# Norlite Corporation

Subject: Fugitive Dust Plan Addendum

ADDENDUM  
FUGITIVE DUST CONTROL PLAN  
NORLITE CORPORATION  
COHOES, NEW YORK

SCI-TECH Project No. 95003

Figure 8-3

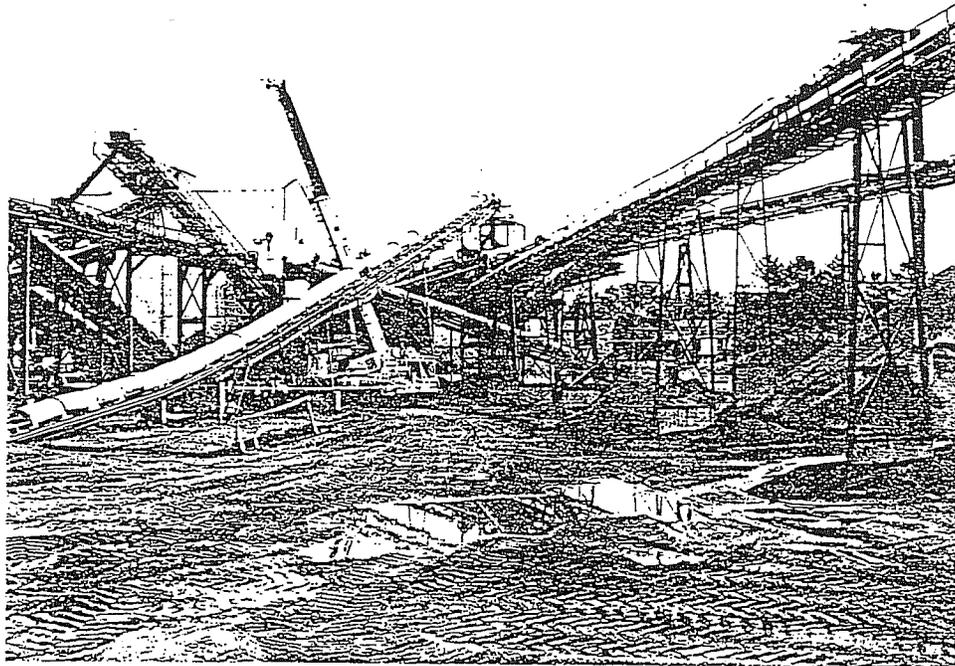
The new block mix field conveyor will be installed in the foreground of this photograph.

Figure 8-5

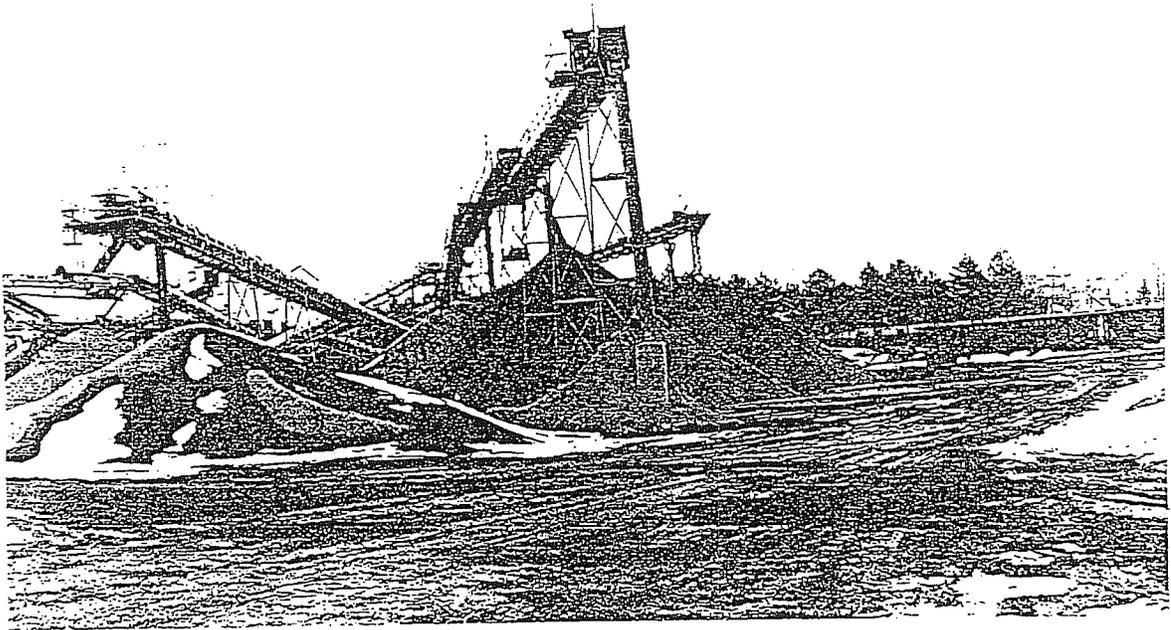
The current block mix conveyor and stacking tubes will be removed after the radial stacking conveyor is installed. The stacking tube plugs frequently and causes excessive drop heights. The radial stacker will raise and lower to control the drop height of block mix.

Figure 8-12

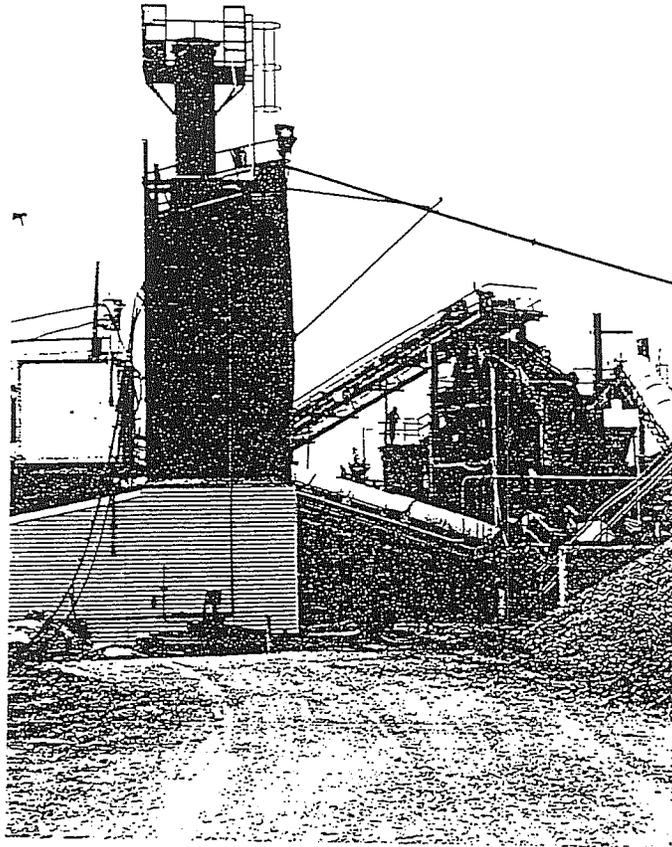
The Soda Ash Silo bin vent was replaced with a much larger Aeropulse bin vent (shown).

Figure 8-17  
Finish Plant Fines Silo and Fines Chute

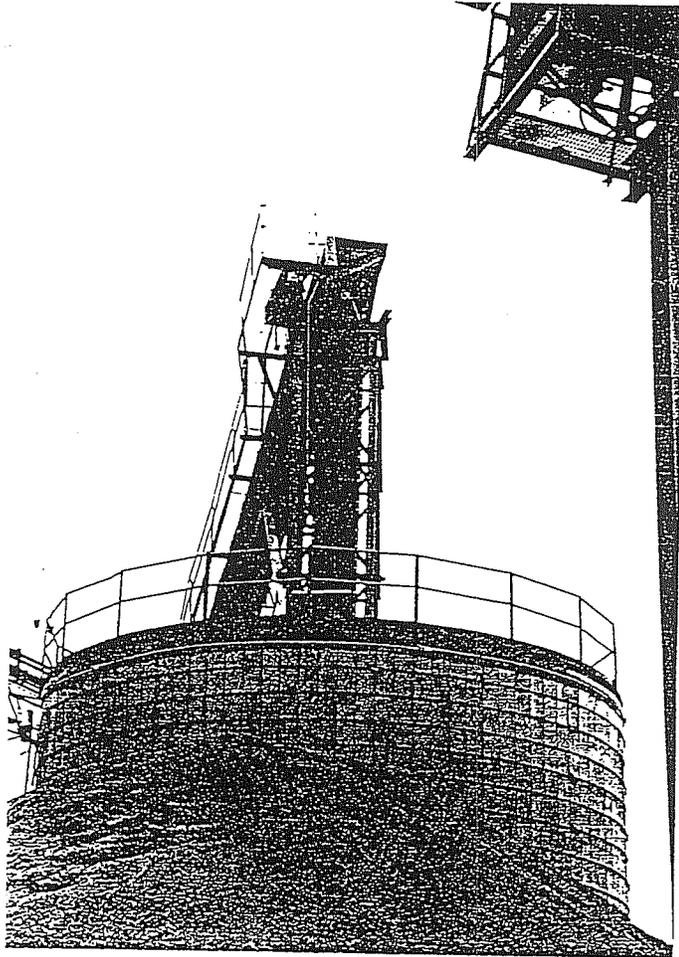
The West face of the fines silo chute (shown) has been redesigned with easily changed, wear resistant plates (also shown).

Figure 8-18  
Shipping Tunnel Mouth Enclosure

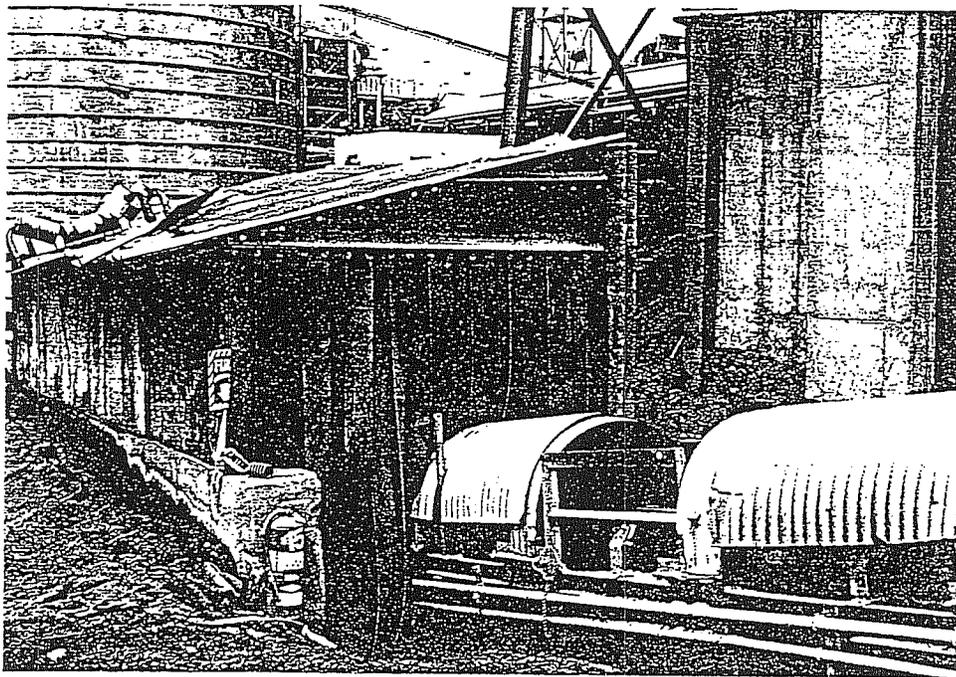
✓ • Shipping Tunnel Mouth: The mouth of the shipping tunnel under the dust and fines silos was covered with a curtain of conveyor belt strips (Fig. 8-18) to prevent dust from escaping the area shown as figure 8-2, Item 9. Under normal operations dust is not produced in this area. During block mix production the level in the bag house dust silos decreases. Some dust is produced when the silo reaches its near empty point. At this point the finish mill operator will stop block mix production or switch to the other dust silo.

The Shipping conveyor belt (right) extends under the three silos (left, not shown). The enclosure covering the mouth of the tunnel will be improved and sealed.

Figure 8-19  
Rear Kiln Seals

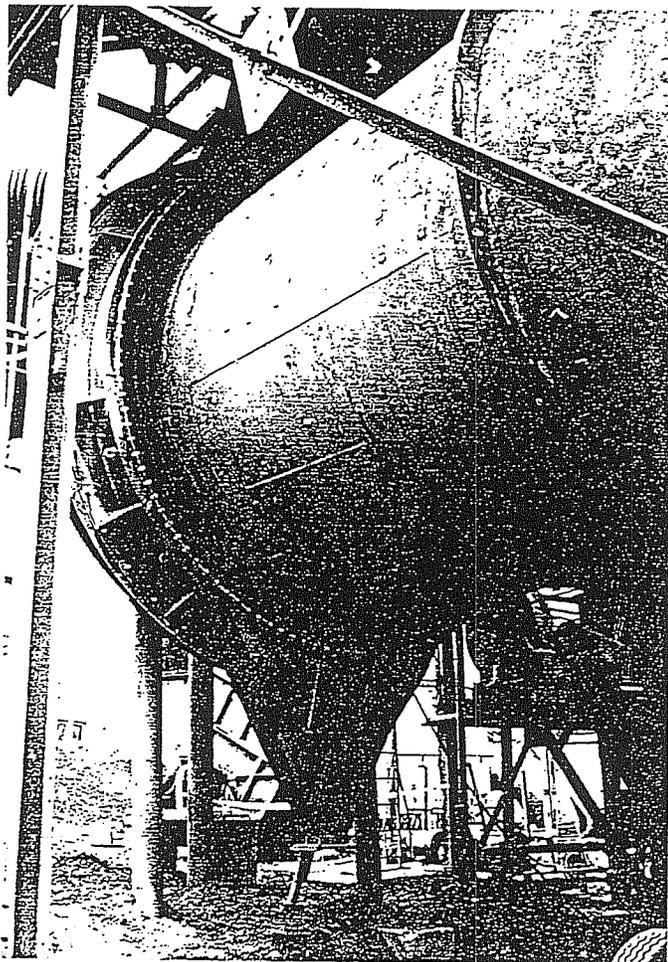
✓ • Kiln Seals: The seals at the rear of each kiln (Fig. 8-2, Item 13) will be maintained during planned kiln shutdowns as needed to prevent emissions from this area (Fig. 8-19).

The seal mechanism and knock out box will be maintained during all planned shutdowns.
